LAW OFFICES OF
BISHOP, LIBERMAN, COOK, PURCELL & REYNOLDS

July 11, 1984

Re: Texas Utilities Electric Company, et al.
(Comanche Peak Steam Electric Station,
Units 1 and 2), Docket Nos. 50-445 & 50-446 OL

Enclosed are Applicants' responses to questions posed by the NRC Staff regarding the motions for summary disposition submitted as part of Applicants' Plan to Respond to the Board's December 28, 1983 Memorandum and Order (Quality Assurance for Design). Additional information will be provided shortly.

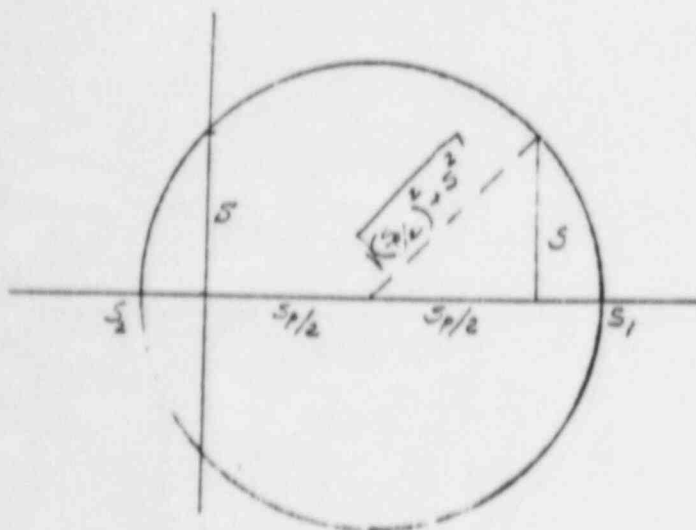
Provide additional information on appropriateness of interaction formula and acceptance criterion for bending in the Richmond insert bolt, including consideration of fatigue.

To address this question Applicants have derived the interaction formula by modelling the bolt as a solid bar having a diameter (h) square equal to four times the effective tensile area divided by π , ie

$$h = \sqrt{\frac{4A_{tens}}{\pi}}$$

The ASME Code, section NB 3232.2 permits the stress intensity of a bolt to equal the yield stress, σ_y .

Under the combined tension and bending loading, the principal stress S_p in the direction of the applied tension is given by

$$S_p = \frac{T}{\pi\left(\frac{h}{2}\right)^2} + \frac{32M}{\pi\left(\frac{h}{2}\right)^3}$$

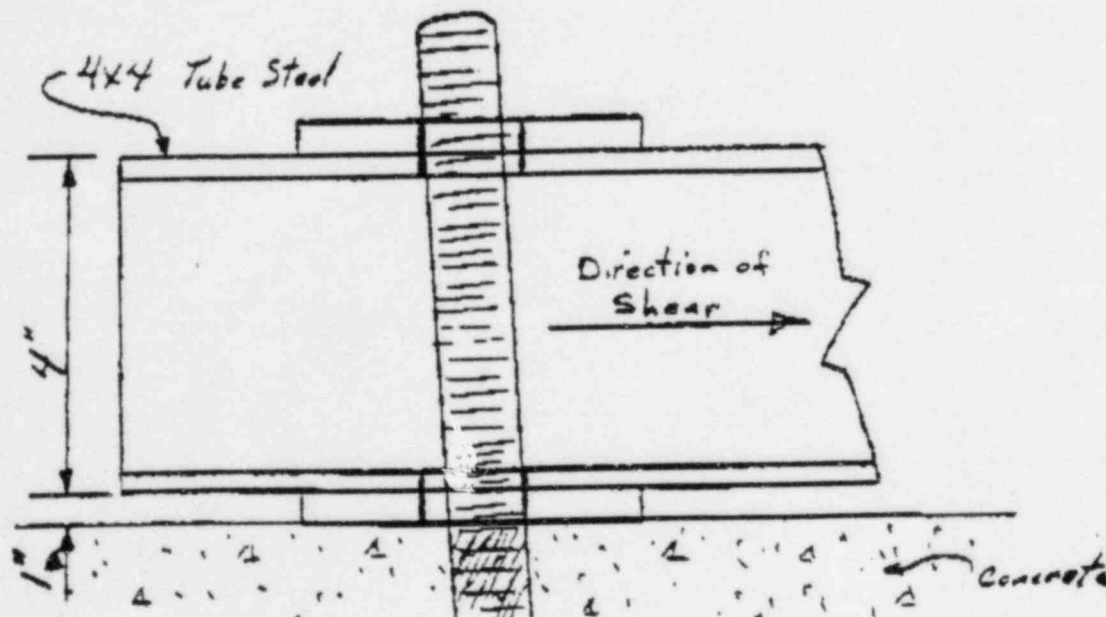
Provide explanation on possible effects of angularity of Richmond inserts.

Figure 1 represents the most probable worst case condition of the misalignment of a Richmond insert bolt in the holes of the tube steel. Misalignment resulting in bolt inclination exceeding one in twenty is not permitted without bevelled washers, and even such misalignment is rare. For holes $1/8"$ larger than the bolt, it can be seen that before any shear can be transferred through the bottom flange, the bolt has to be deflected $1/8"$ at the top flange (0.2 inches for a one in twenty angularity). This situation is not unlike the situation involved in the distribution of shear to a ^umultibolt connection. It is well recognized in that situation that some bolts in the connection, or some other part of the connection, may yield in order to bring all bolts into the shear reaction, so that ultimately all bolts share. The bolt shown in Figure 1 has a misalignment that is within the normally accepted construction tolerances. As the shear load on the connection is increased, a bending moment will be induced in the bolt. At some point, however, the bottom flange will be brought into contact with the bolt, and in the ultimate condition, the majority of the shear force will be transferred through the bottom flange, just as it would in a connection with no misalignment.

The question which must be answered is whether the bolt has the flexibility to close the $1/8"$ gap before failing. Looking at Attachment A to Applicants'

Richmond Insert Affidavit, one can see that these connections have typically quite ample flexibility. The smallest ultimate deflection of any bolt in that series of tests was 0.56". It should be noted that these tests were conducted with a test plate only. The bolt deflection of interest would have been higher. These tests were for 1 1/2 inch inserts. Similar results were obtained from the 4/84 tests on Richmond inserts (Attachment B to the same Affidavit). For the 1 inch bolt in these tests, the smallest shear test deflection was 0.22". However, assuming that this was the deflection at the top of the test plate (1" from the concrete), the deflection at the top flange of Figure 1 (about 5" from the concrete) would be considerably larger. These tests confirm that the Richmond inserts, even when used with high strength bolts (all prior deflections were obtained for high strength bolts) have the flexibility necessary to accomodate the misalignment of bolts in the field. An inspection of the results of Attachment F to Applicants' Richmond Inserts Affidavit indicates clearly that the use of an A-36 rod with the Richmond insert (the most common practice at CPSES) will also allow quite ample flexibility to account for these construction tolerances. These effects are well recognized in the AISC Code. Pages 5-14 and 5-15 of the AISC, 8th Edition describe Type 2 construction (i.e pinned joints), which is the type of "simple framing" assumed in the design of the Richmond insert-tube steel structures. Those pages state "Type 2 and 3 construction may necessitate some inelastic, but self-limiting, deformation of a structural steel part."
